EXT-91-04.067  
THE TOLEDO EDISON COMPANY  
NUCLEAR ENGINEERING  
DOCUMENT REVIEW

OWN. BY D. P. GERHARD	SFAS SURVEILLANCE INSERT OUTLINE	SCALE NONE
CHKD. BY D. P. GERHARD		
PASSED BY M. N. VICKERS		
APPROV. BY R. K. KENNEDY		
STD. ISPL. DATE 5/28/91	TOLEDO EDISON DAVIS BESSE POWER STATION	DO NOT SCALE - USE DIMENSIONS ONLY
P.O. NO. S 025236 D91		SCALE NONE
REV. NO. 6		SCALE NONE

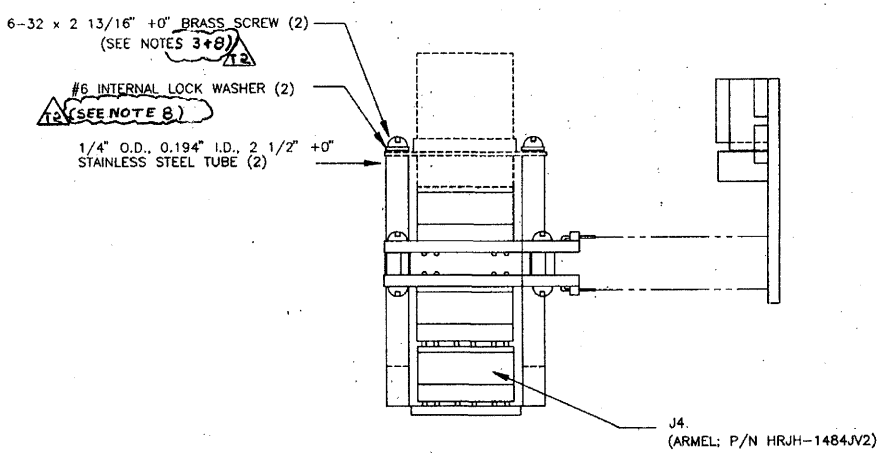
REVISIONS			
REV	DESCRIPTION	DATE	APPROVAL
6	REMOVED WASHER BETWEEN STANDOFF SCREWS AND PC BOARDS	5/28/91	OPG MM MNV

(SEE NOTE 6)
